Agenda Item # 8

SUB-002891-2024

Dailey-Pollard Subdivision

DAILEY-POLLARD SUBDIVISION

DETAIL SITE PLAN

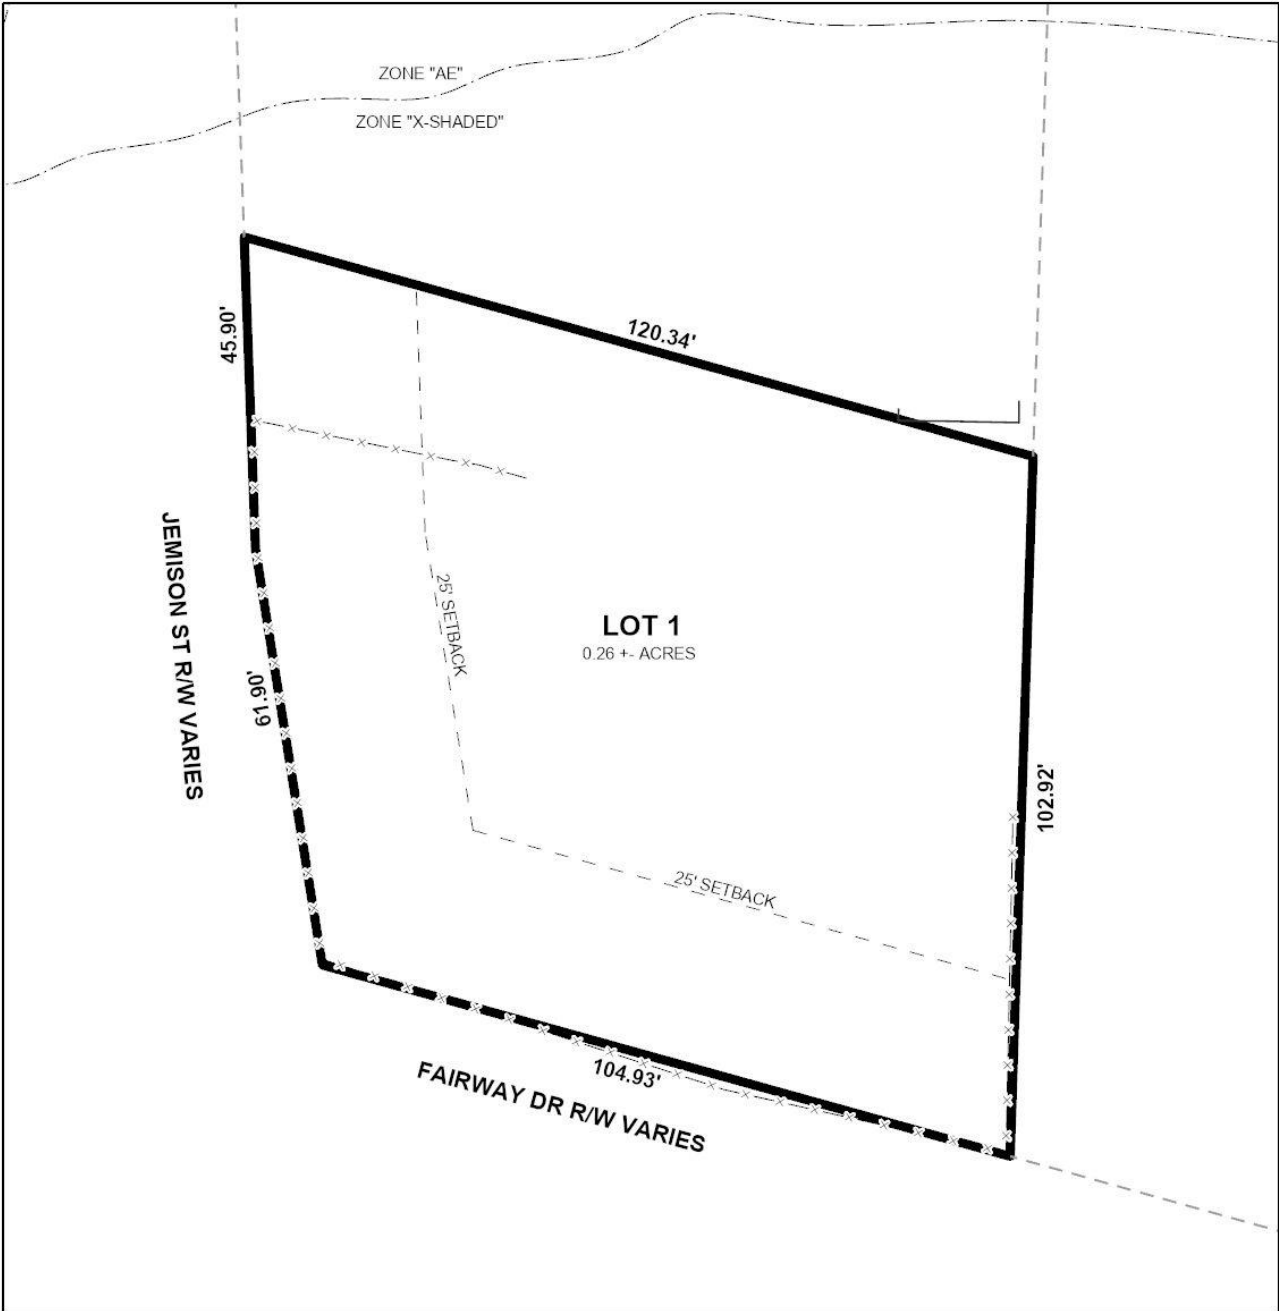
The site has frontage along Jemison Street, a minor street with curb and gutter requiring a 50-foot right-of-way, and Fairway Drive, a minor street without curb and gutter requiring a 60-foot right-of-way. The preliminary plat depicts both rights-of-way as "varies". As such, the Final Plat should be revised to accurately label the aforementioned rights-of-way and illustrate dedication sufficient to provide 30 feet from the centerline of Fairway Drive.

Proposed Lot 1 is a corner lot requiring at least a 25-foot corner radius where Jemison Street and Fairway Drive intersect, per Section 6.C.6. of the Subdivision Regulations. The preliminary plat does not depict a corner radius. Section 6.B.12. of the Subdivision Regulations allows a 20-foot corner radius, but anything less requires approval from the City Engineer. As such, the plat should be revised to provide dedication and illustrate at least a 25-foot corner radius at the intersection of Jemison Street and Fairway Drive. If a reduced corner radius is approved, approval from the City Engineer and a waiver of Section 6.C.6. will be required. Additionally, revision of the size and dimensions of Lot 1 should be adjusted for dedication on the Final Plat.

A 25-foot front yard setback is illustrated along all frontages on the preliminary plat, in compliance with Section 64-2-5.E. of the Unified Development Code (UDC) for lots in an R-1 suburban district; however, the lot is within an urban sub-district and only requires a 5-foot front yard setback. As such, the plat should be revised to illustrate a compliant 5-foot front setback along Fairway Drive and Jemison Street, if approved, subject to right of way dedication along Fairway Drive.

The proposed lot exceeds the minimum size requirement for lots served by public water and sanitary sewer in an R-1 urban district. If approved, the lot size should be retained on the Final Plat in both square feet and acres, adjusted for dedication; or a table should be furnished on the Final Plat providing the same information.

1. Dedication sufficient to provide 30 feet from the centerline of Fairway Drive;
2. Revision of the Final Plat to accurately label the rights-of-way of Jemison Street;

3. Dedication sufficient to provide a 25-foot corner radius at the intersection of Jemison Street and Fairway Drive, in compliance with Section 6.C.6. of the Subdivision Regulations;

4. Retention of the lot size in both square feet and acres, adjusted for dedication, or the furnishing of a table on the Final Plat providing the same information;

5. Revision of the Final Plat to illustrate a 5-foot front setback along Fairway Drive and Jemison Street on the Final Plat;
6. Placement of a note on the Final Plat stating that no structure may be constructed or placed within any easement without the permission of the easement holder;
